SUBJECT: Final Site Closure Sampling Work Plan
DP011 (Building 3 Drywell AOC)
Former Griffiss Air Force Base (AFB) Rome, New York
Contract Number FA8903-10-D-8595
Delivery Order 0014

Site Closure Sampling Work Plan for DP011 Building 3 Drywell AOC
EPA Comments, Doug Pocze
Emailed – December 2, 2011

**SITE CLOSURE SAMPLING
WORK PLAN**

**DP011 (Building 3 Drywell AOC)
Former Griffiss Air Force Base
Rome, New York**

Figure 1
DP011 (Building 3
Drywell AOC)
Sampling Location

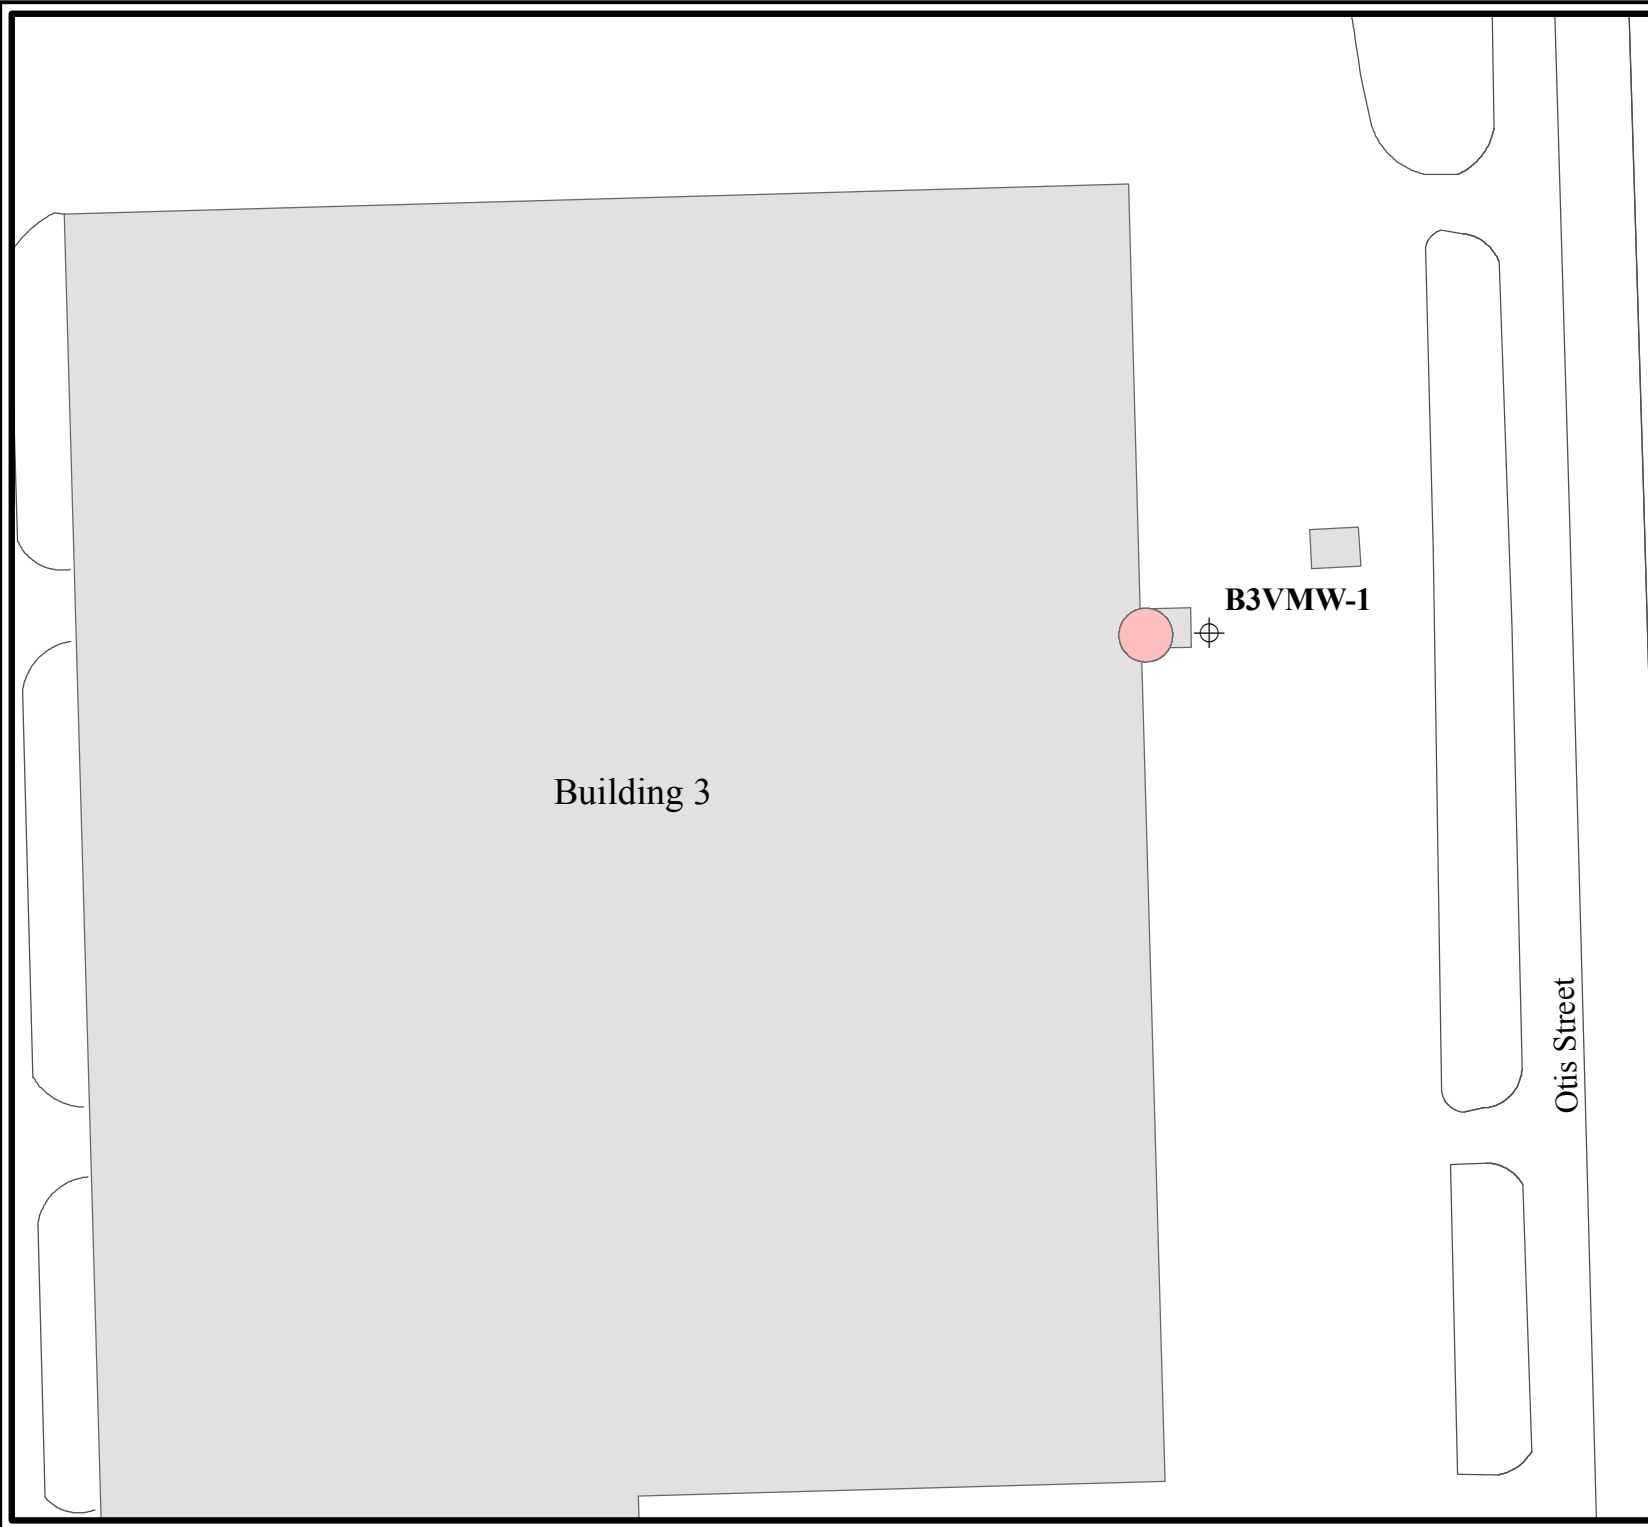
CAPE wishes to take 1 sample from well B3VMW-1 and compare it to groundwater standards. As stated in the document, if the sampling results are below the NYS Class GA Groundwater Standards, then the site is closed and no further action will be required. However, the plan also states in Section 2.2.2 that, "the risks to these workers were not quantitatively addressed due to the inability to collect soil samples from 6 to 8 ft bgs at the site." Because of this fact and due to the detections of SVOCs, metals and TRPH in the groundwater, the AF elected to perform only an Industrial/Commerical risk assessment. Although this risk assessment was found to be acceptable and No Further Action was require (for industrial and commercial reuse) institutional controls and deed restrictions were required because the risk assessment did not evaluate residential or unrestricted reuse and it fail to use the sampling results of the soil below 6 to 8 bgs. I do not understand how only 1 groundwater sample would suffice to indicate the restrictions can be removed.

COMMENT 3 - I do not understand how only 1 groundwater sample would suffice to indicate the restrictions can be removed.

RESPONSE - It is believed that only one groundwater sample will be needed to assess groundwater conditions. This is concluded as the site is relatively small (approximately 20 ft by

20 ft), the drywell was removed and soils were excavated to 10 ft bgs, and previous groundwater sampling results showed contamination in the vicinity of the existing well.
